# SERVICE BULLETIN

## Large Air Motor Change

MODELS AFFECTED: 10" (66651), 12" (66506)  
REPLACEMENT VALVE ASM.: 637111

RELEASED: 9-1-98  
REVISED: 1-10-12  
BULLETIN: #3-98  
FORM: 4298-2  
REV: 01

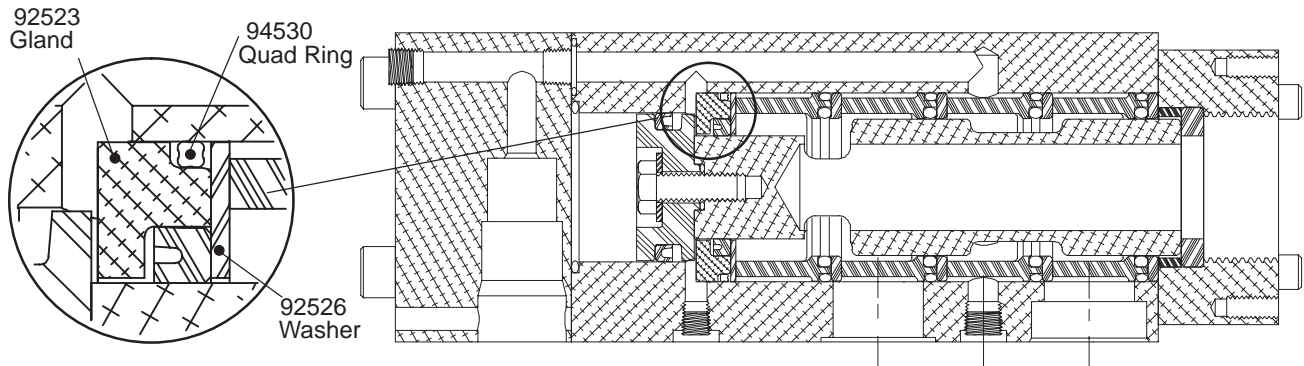
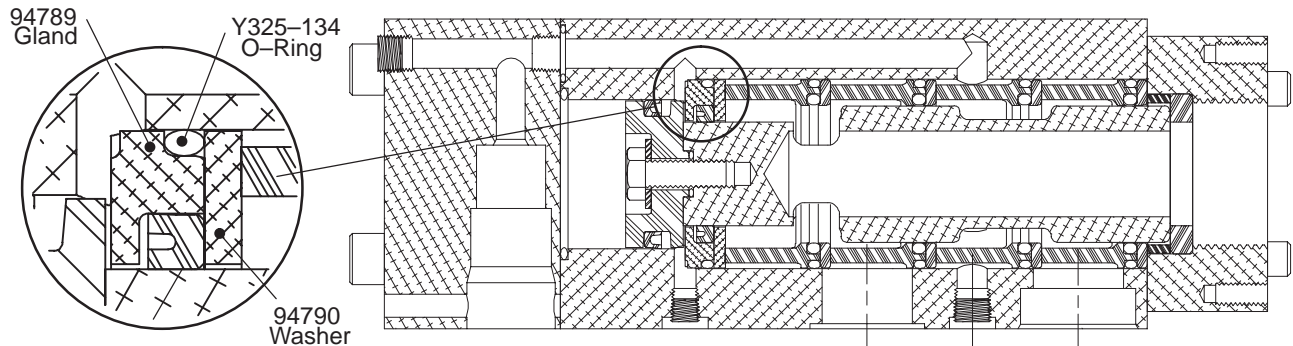
These part changes improve the outer seal on the Major Valve Gland.  
The following changes can be made to update older motors.

- The gland has a different design.
- The quad ring has been replaced by a Buna O-ring.
- The washer is thicker, it moves the gland away from the exhaust outlet.
